HOWIE POINT (NORTH 1)
FROM STA 0+00.00
TO STA 28+00.00

MEADOW RANCH II & III

GRADING & EROSION CONTROL PLAN COVER SHEET

DEVORSS VIEW (SOUTH 2A)
 FROM STA 28+00.00
 TO END
C1.11
 SHEET 11 OF 12

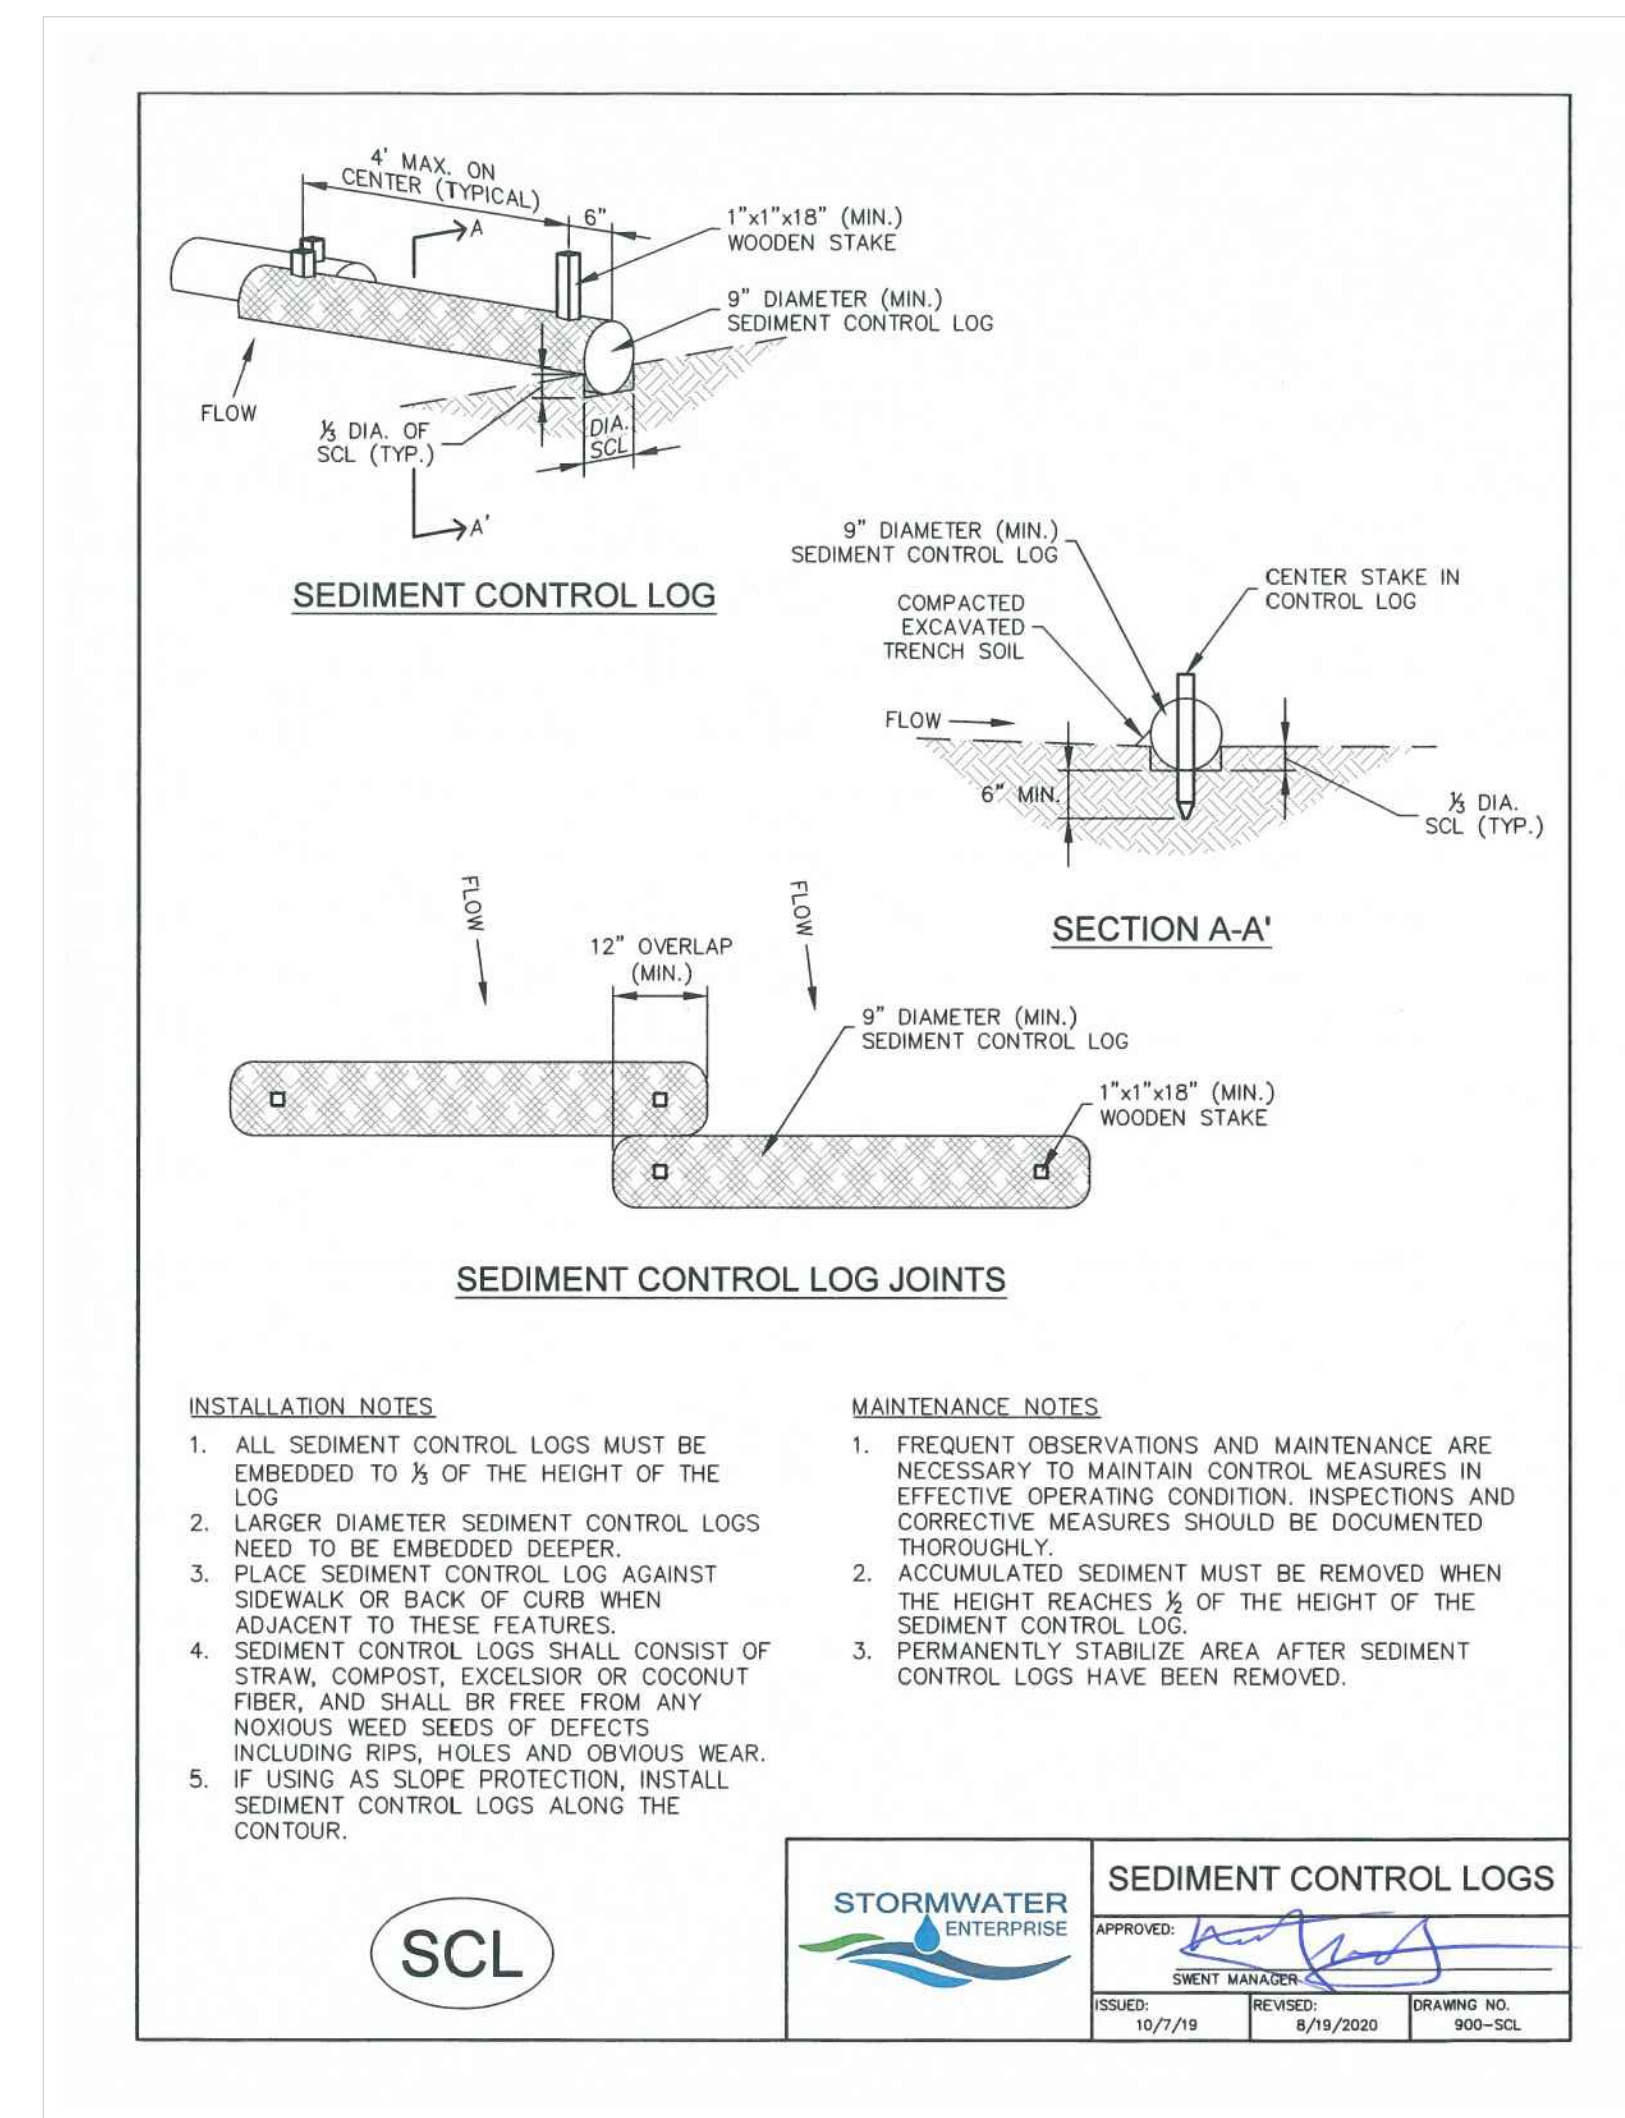
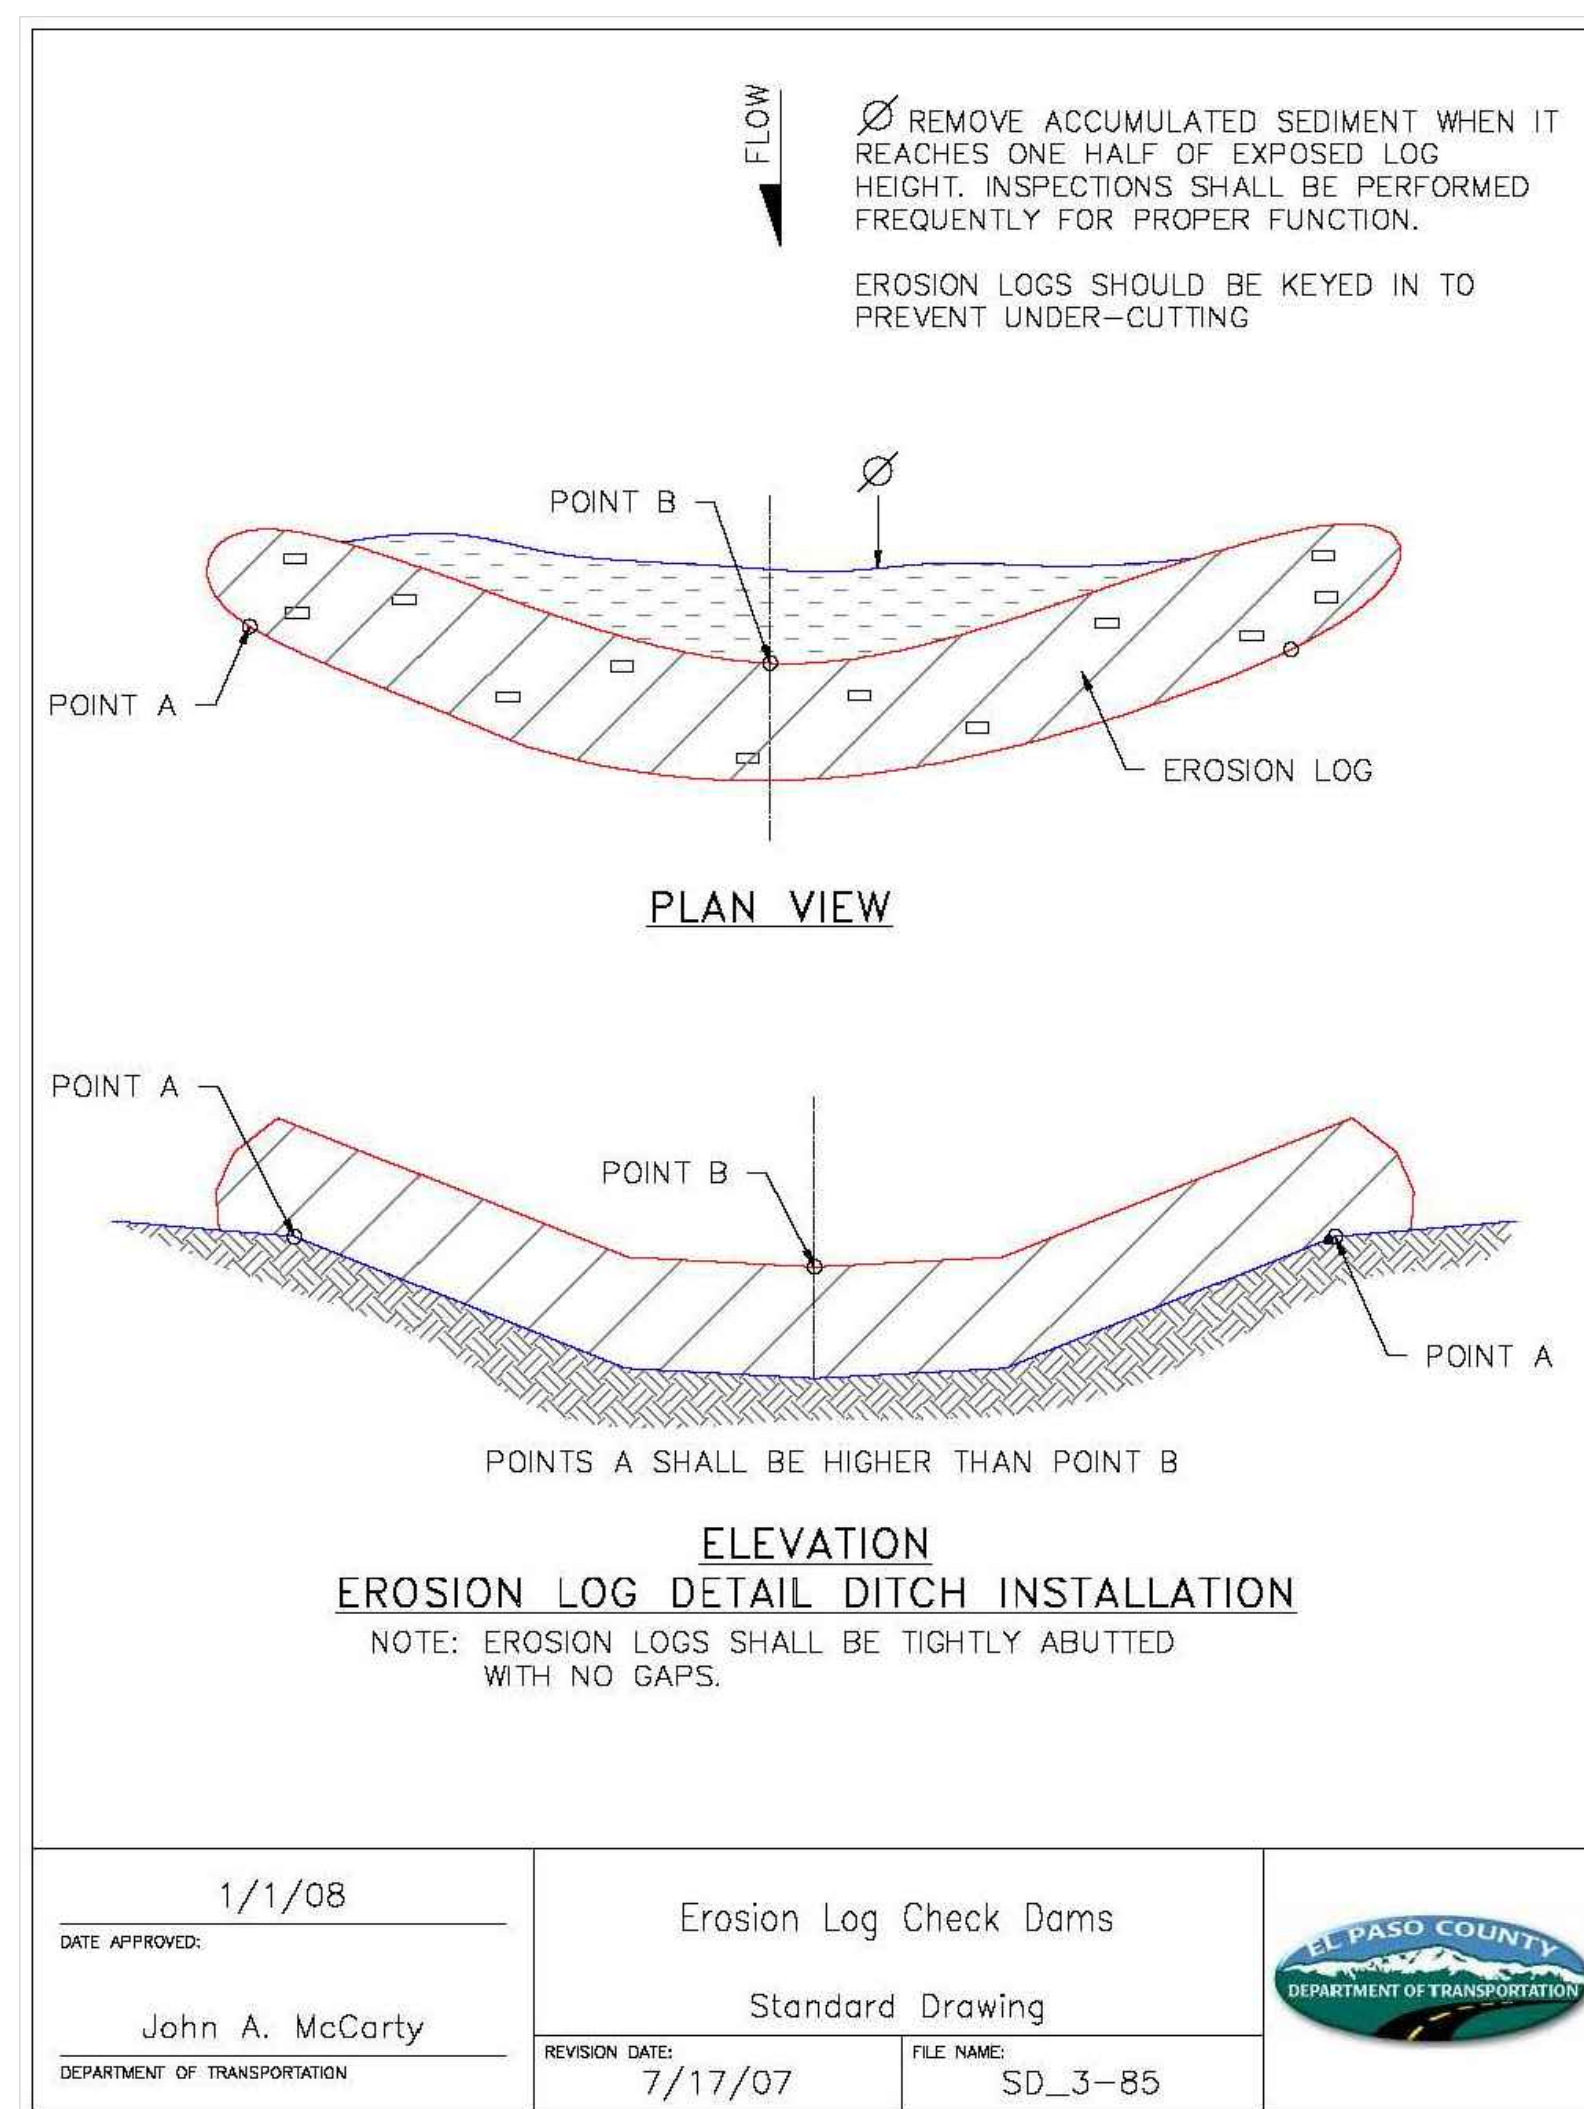
Add details for stabilized staging area, soil stockpiles, and TSB details.
